**CITY OF SHERWOOD  
HEARINGS OFFICER STAFF REPORT  
June 11, 2026**

**PINOT GLEN  
39-LOT RESIDENTIAL SUBDIVISION  
LU 2025-012 SUB**

**To: Joe Turner, City of Sherwood Hearings Officer**

**From: Arthur Graves, Associate Planner**

**Figure 7.401 — Block Connectivity**

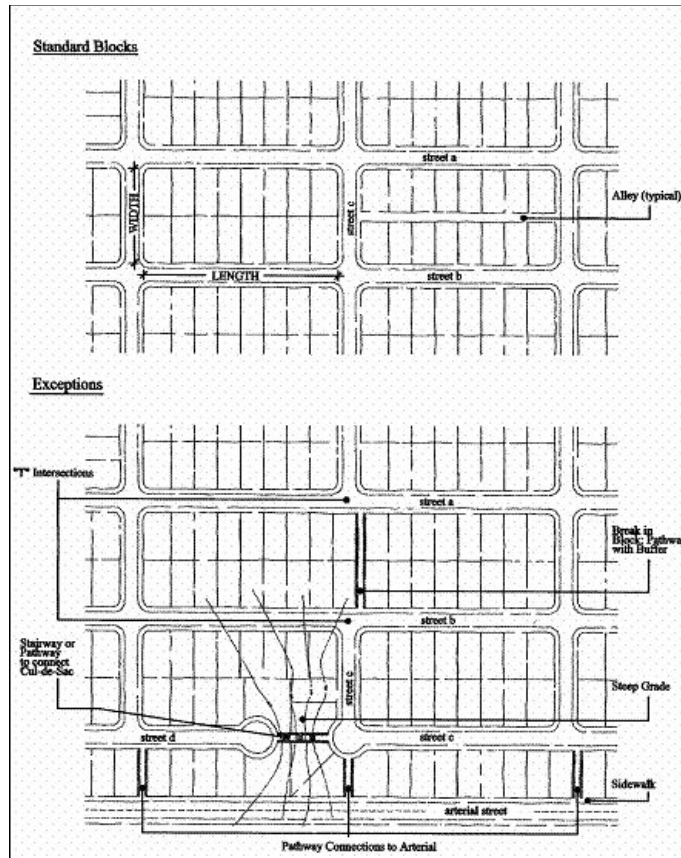
**FINDINGS:** Lots 22-30 will be served by additions to existing streets, SW Derby Terrace, SW Locksley Lane, and SW Oxford Terrace, and with the new “Street A”, creating a new block consistent with required block size and length. However, the proposed block defined by SW Derby Terrace to the west, SW Copper Terrace to the east, Street A to the north, and SE Cereghino Lane to the south, exceeds the five-hundred thirty (530) feet block length standard. The applicant has requested a Modification to this standard addressed in 16.106.020.E.

**CONDITION OF APPROVAL B3:** Prior to Final Plat Approval a revised plan shall be submitted including revised street widths and bicycle and pedestrian connection on what is currently lot 10.

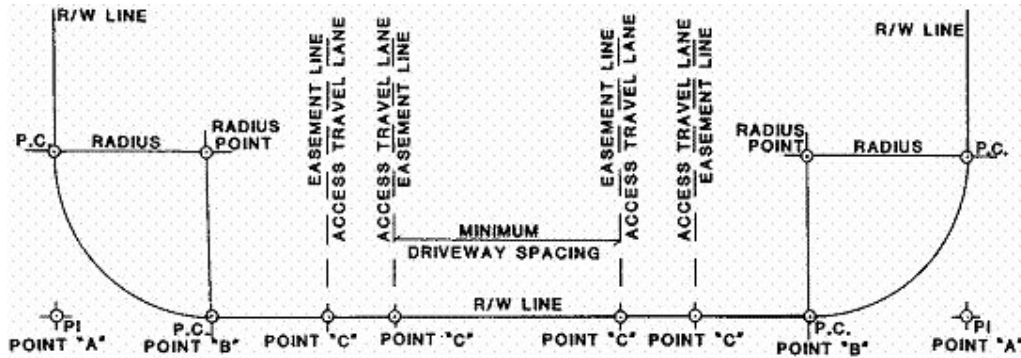
**FINDINGS:** Per comments from the City Engineer (Exhibit B5), a “bulb-out” shall be constructed on the west side of SW Copper Terrace at its intersection with SW Cereghino Lane.
